Project	<b>IEEE 802.16 Broadband Wireless Access Working Group</b> < <a href="http://ieee802.org/16">http://ieee802.org/16</a> >	
Title	<b>Method of providing MBS Feedback</b>	
Date Submitted	<b>2005-01-10</b>	
Source(s)	<p>Kiseon Ryu, Ronny(Yong-Ho) Kim, Changjae Lee</p> <p>LG Electronics 533,Hogye-1dong,Dongan-gu, Anyang-shi,Kyongki-do,Korea</p>	<p>Voice: 82-31-450-4387 Fax: 82-31-450-7912 <a href="mailto:ksryu@lge.com">[mailto:ksryu@lge.com]</a> <a href="mailto:ronnykim@lge.com">[mailto:ronnykim@lge.com]</a> <a href="mailto:cjlee16@lge.com">[mailto:cjlee16@lge.com]</a></p>
Re:	The document supports a comment at Sponsor Ballot on 802.16e/D5a document	
Abstract	The document suggests text changes to provide MBS Feedback	
Purpose	The document is for consideration during Sponsor Ballot comments resolution	
Notice	This document has been prepared to assist IEEE 802.16. It is offered as a basis for discussion and is not binding on the contributing individual(s) or organization(s). The material in this document is subject to change in form and content after further study. The contributor(s) reserve(s) the right to add, amend or withdraw material contained herein.

# Method of providing M

**Figure 20e—MBS Feedback header format**

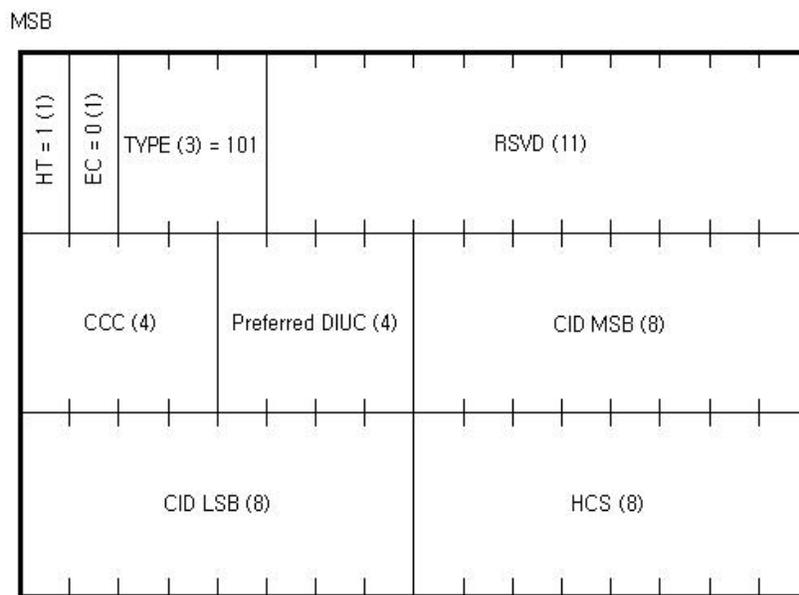
*[Insert the following at line 42, Page 22 : ]*

The MBS Feedback header shall consist of CCC, Preferred DIUC, and Multicast CID, and shall not contain a payload. The MBS Feedback header is illustrated in Figure 20e.

The MBS Feedback header shall have the following properties ;

- The length of the header shall always be 6 bytes.
- The HT field is set to 1.
- The EC field shall be set to 0, indicating no encryption.
- The CCC field shall be set to 4 LSB of Configuration Change Count value of DCD defining the burst profile associated DIUC.
- The Preferred DIUC field shall be set to the value of the DIUC preferred by the MSS.
- The CID field shall be set to the Multicast CID on that MBS data is transmitted.
